Better Housing by Design

Revised Proposed Draft

Volume 3:

Additional Zoning Code Amendments

Figure 130-1
Step-Down Height Adjacent to Residential Zones

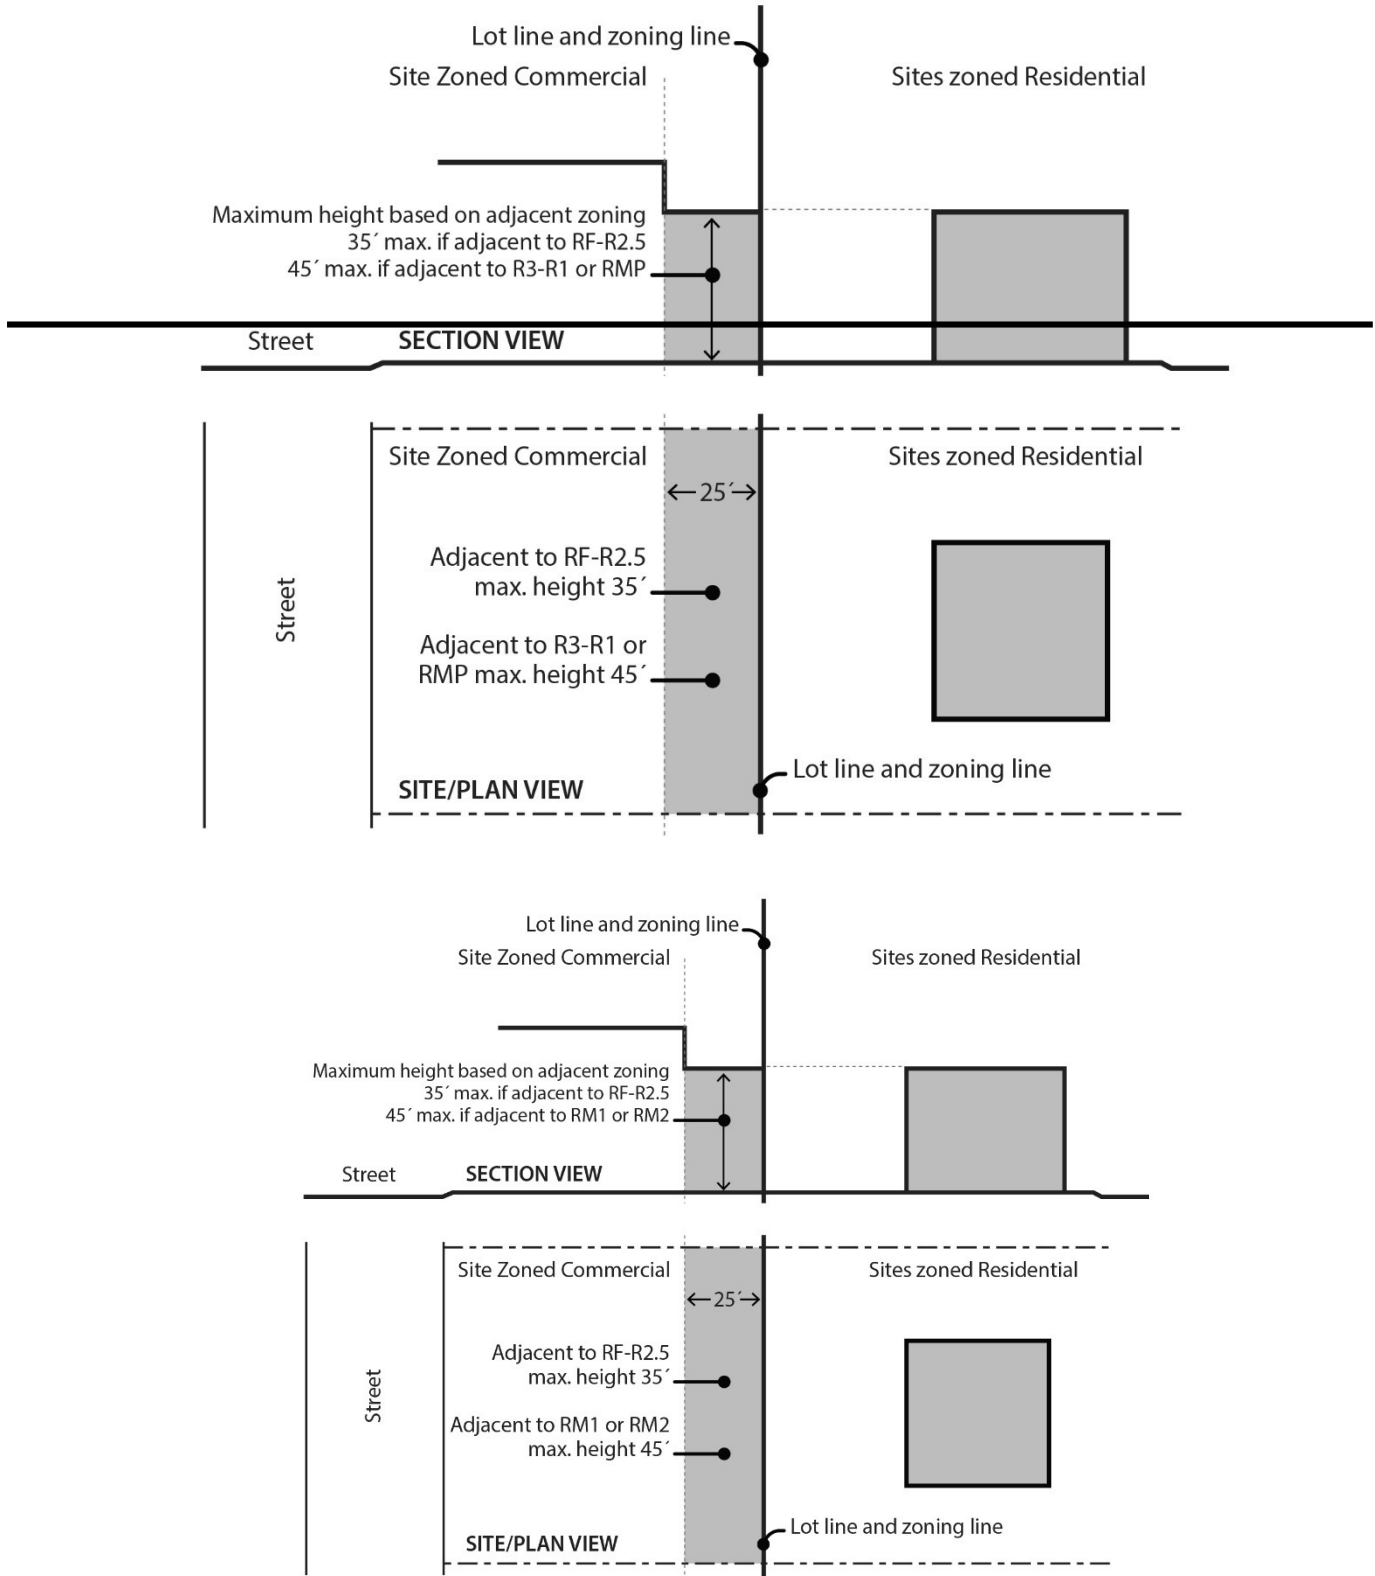
Amendments to this section and its graphic are updates to the multi-dwelling zone names.

33.130.212 Floor Area and Height Bonus Options

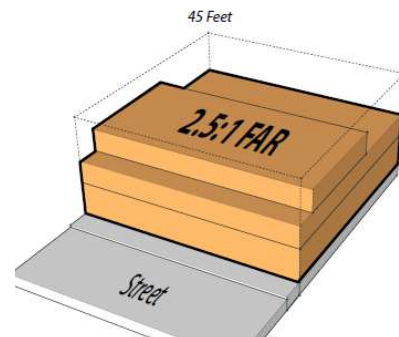
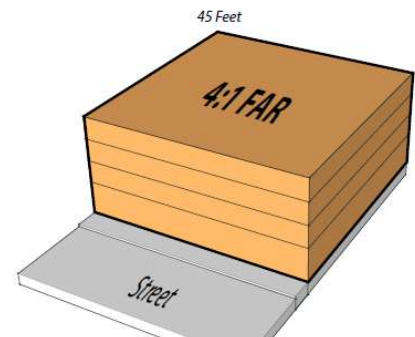
Amendments to this paragraph would allow the use of FAR bonuses in the commercial/mixed use zones within historic and conservation districts, bringing consistency with allowances in the multi-dwelling zones. Development proposals in historic districts will be subject to Historic Resource Review, which considers context in determining the appropriate scale of new development (scale allowed by FAR bonuses may not always be approved). The majority of mixed use zoning in historic and conservation districts consists of the CM2 zone, which has a base maximum FAR of 2.5 to 1. Bonuses in this zone would allow up to a 4 to 1 FAR, with base height in historic and conservation districts limited to 45 feet.

Building massing of current maximum FAR and proposed bonus FAR. The maximum bonus scale of four stories is similar to historic buildings in some historic districts.

Figure 130-9
Facade Articulation

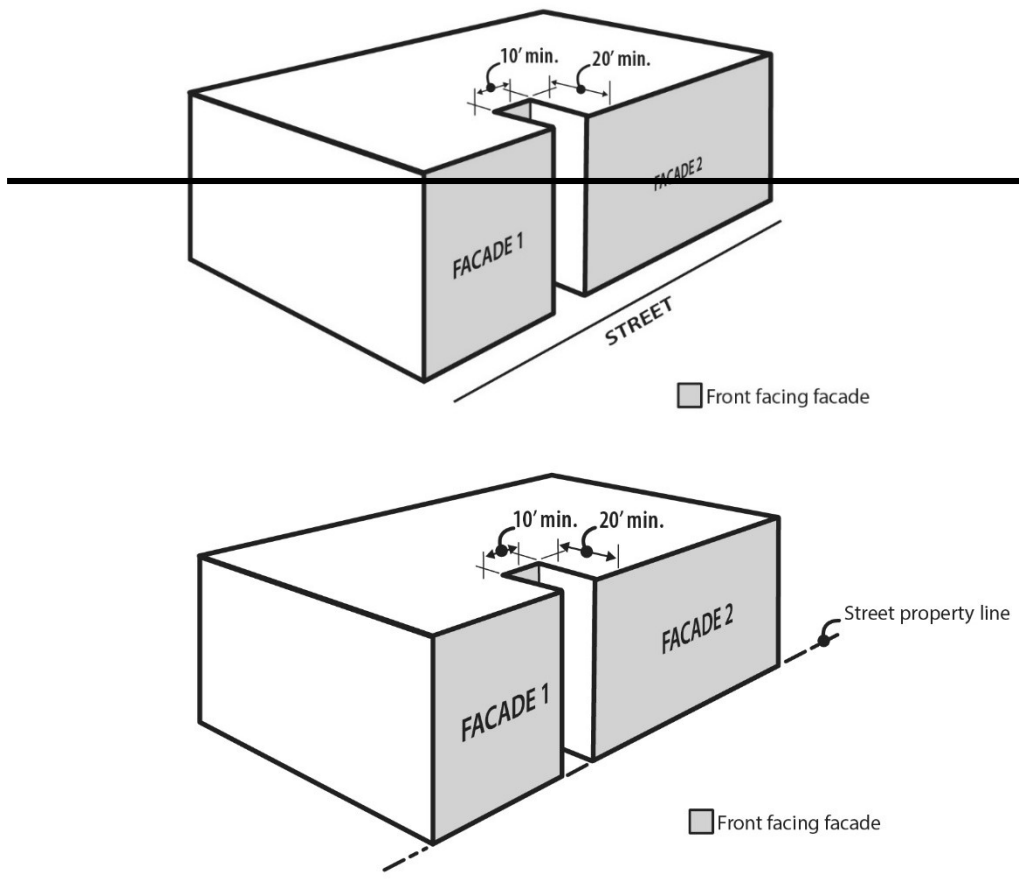
Figure 130-9 is being replaced to provide greater clarity. The 20-foot dimension in the accompanying text is intended to be measured from the street property line, but the graphic shows the measurement starting at the building façade, which appears to be set back from the street. The corrected graphic shows both the façade and the street lot line at the same location.

Map 130-2

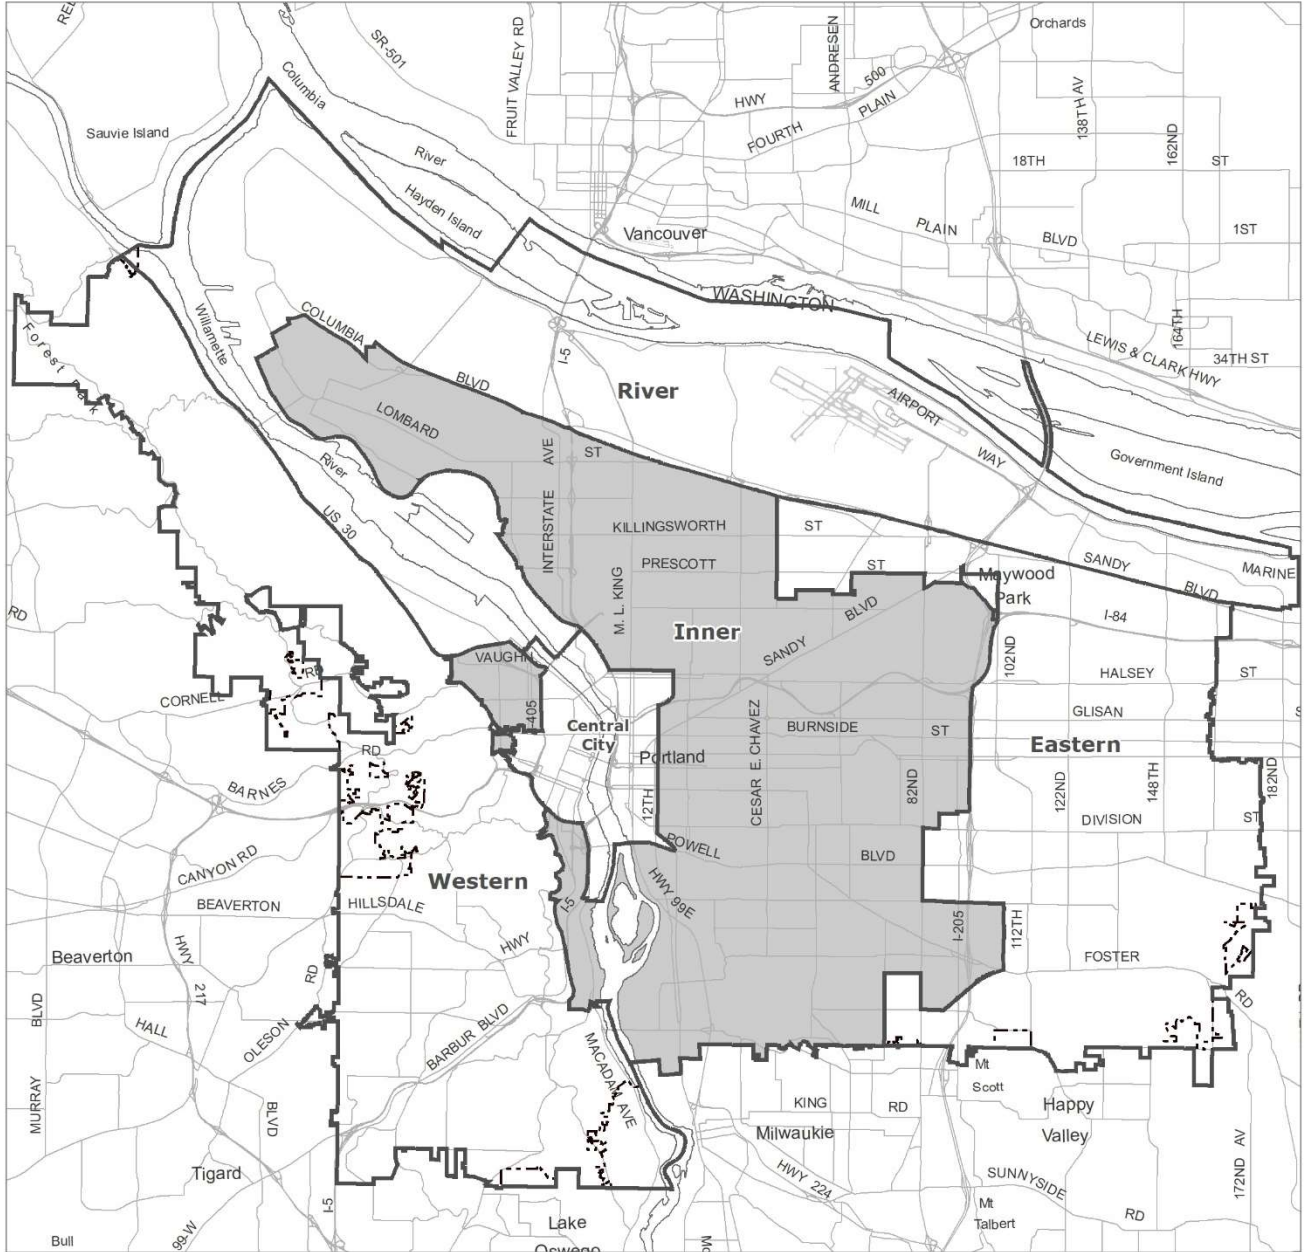
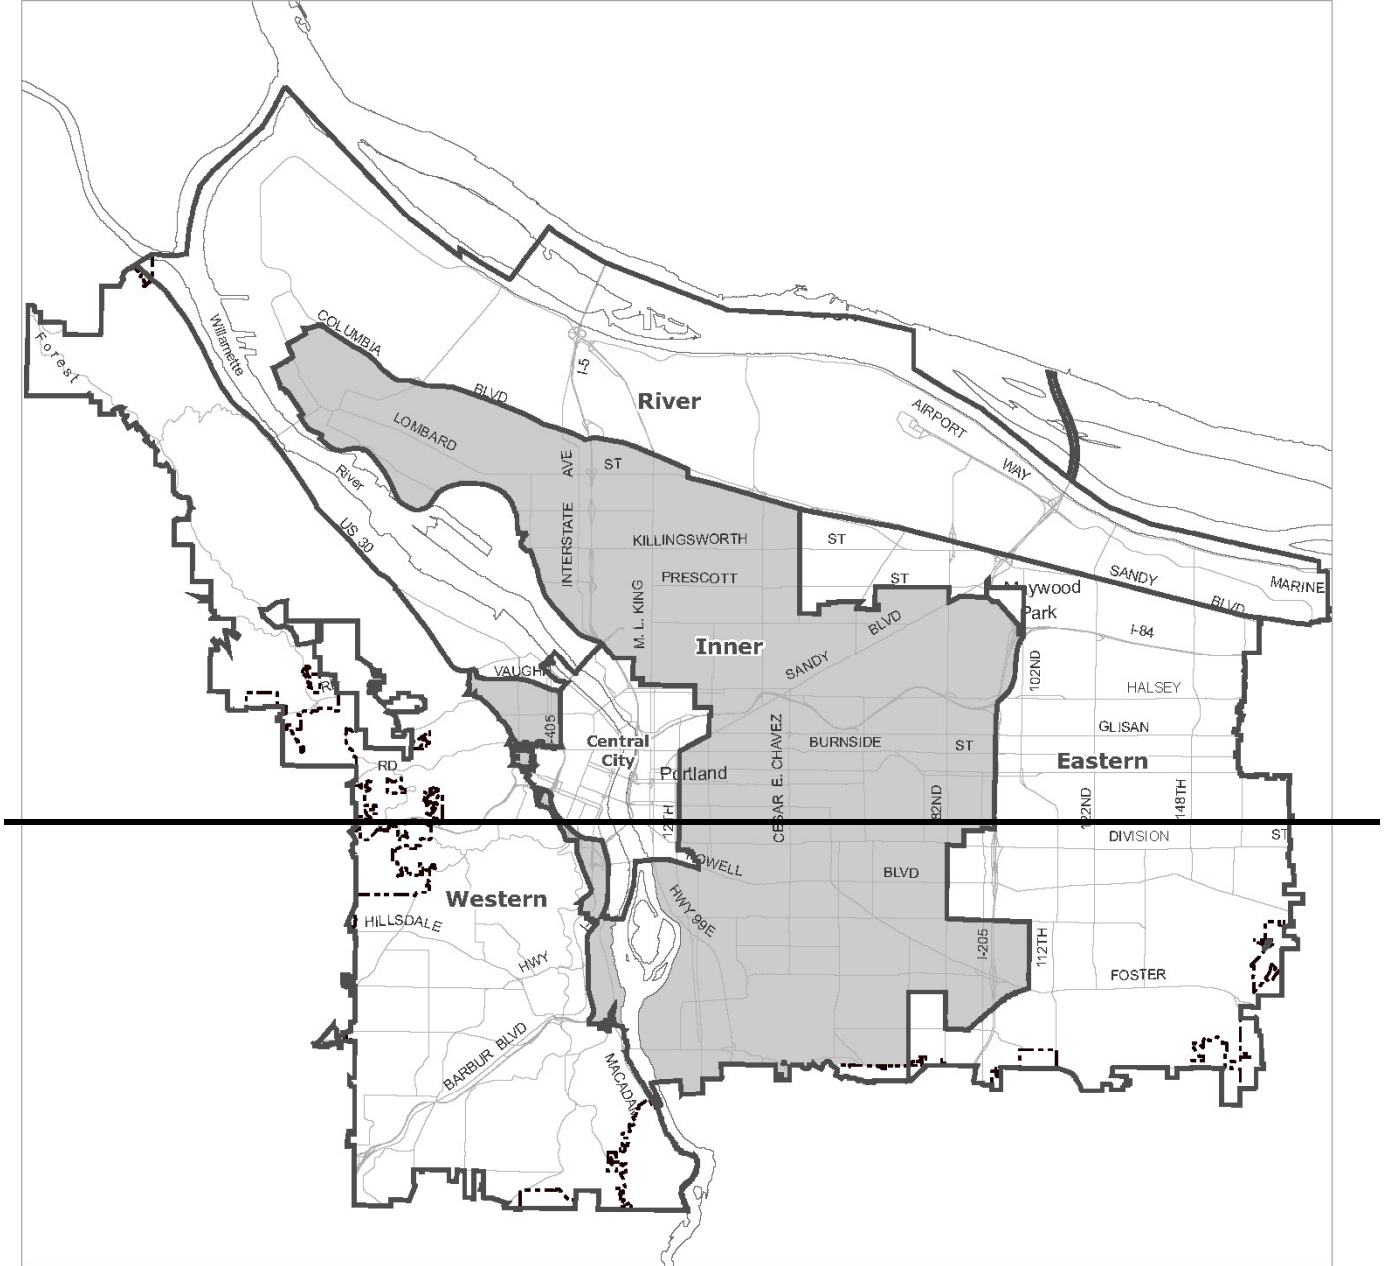
The Pattern Areas map is being amended to make corrections to the pattern area boundaries. The most significant change is that the *Central City Pattern Area* boundaries are being amended to correspond to the *Central City Plan District* boundaries. The previous version of the Pattern Areas map was based on draft boundaries for the *Central City Plan District* that were not adopted (it included small portions of *Lower Albina*, *Kerns*, and a small area near the *Clinton* light rail station that had been considered for inclusion in the *Central City Plan District*, but were not ultimately included). Other changes include corrections to pattern area boundaries, mostly to avoid situations in which boundaries cut across properties and to more accurately reflect existing urban patterns. The revised boundaries use streets and property lines as boundaries and take into account block patterns and topography. The Pattern Areas map boundaries affect building coverage and landscaping standards, which vary by pattern area.

Figure 561-1
Height limits on sites abutting RF - ~~R1RM2~~ zones

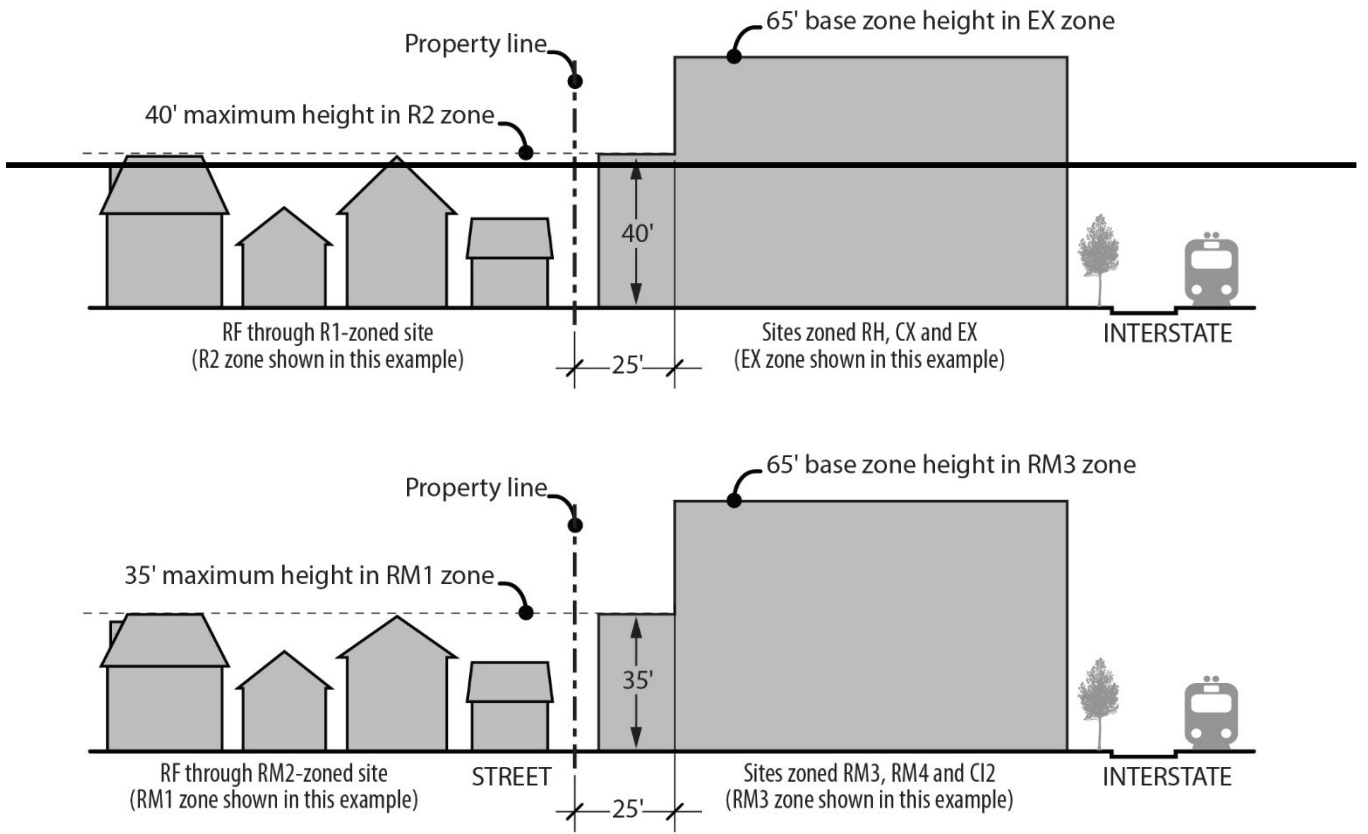
Amendments to the text on this page are updates to the multi-dwelling zone names. Figure 561-1 is also being amended to show the maximum height 35-foot height of the RM1 zone, instead of the 40-foot height of the R2 zone.

Figure 561-2
Height limits on sites across a street from RF – ~~RM2R1~~ zones

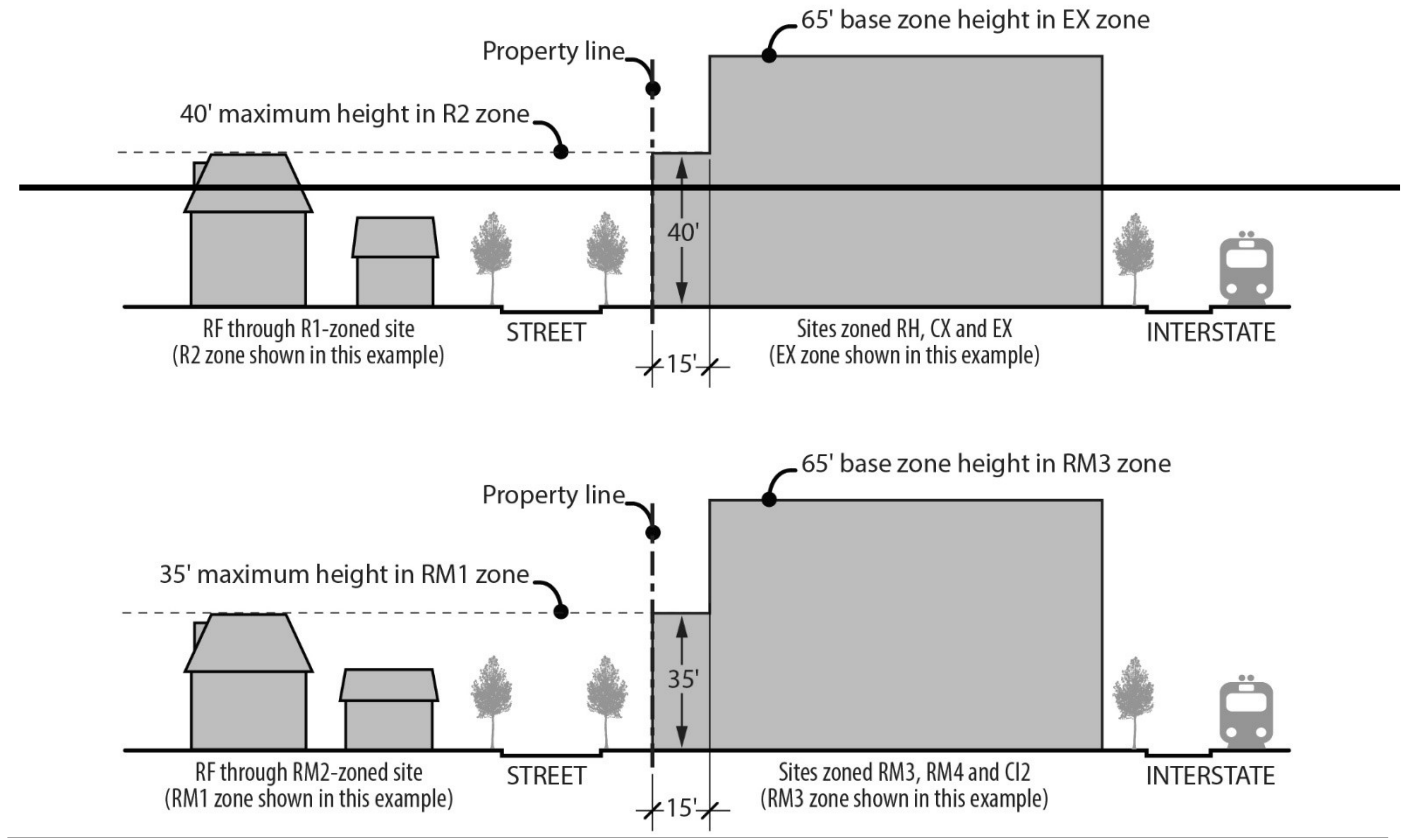
- Updates to the multi-dwelling zone names.
- Figure 561-2 is being amended to show the maximum 35-foot height of the RM1 zone, instead of the 40-foot height of the R2 zone.

Figure 575-1
Height limits on sites abutting RF – RM2R1 zones

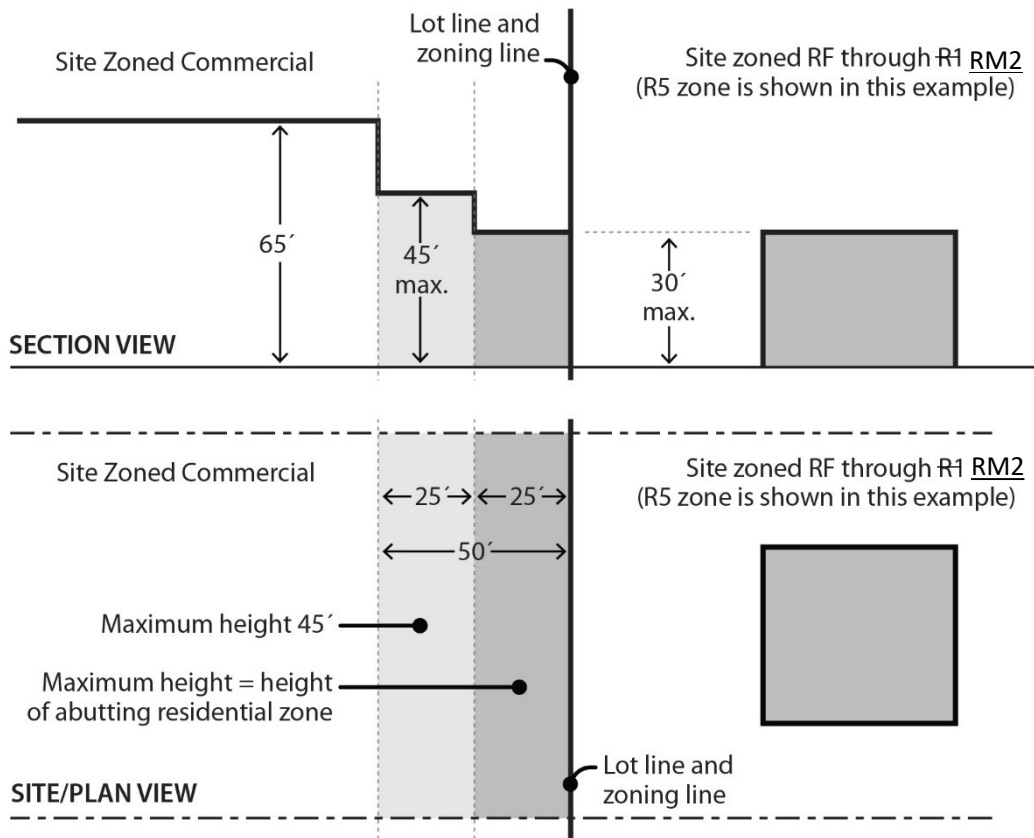
Amendments to the graphics on this page are updates to the multi-dwelling zone names.

Figure 575-2
Height limits on sites across a street from zones RF - RM2R1 zones

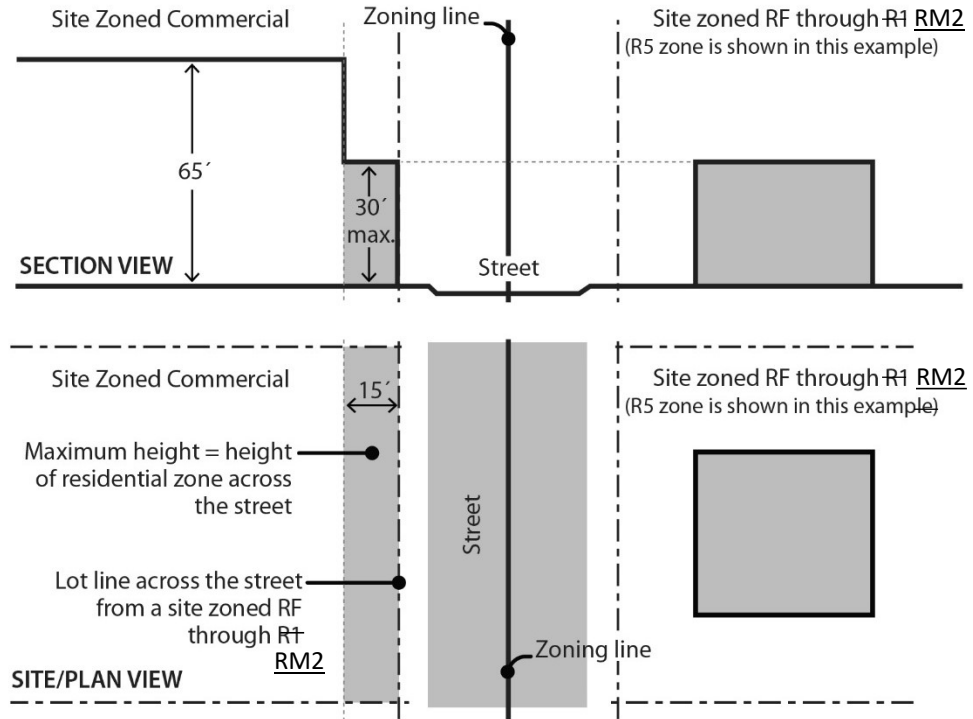
Amendments to the graphics on this page are updates to the multi-dwelling zone names.
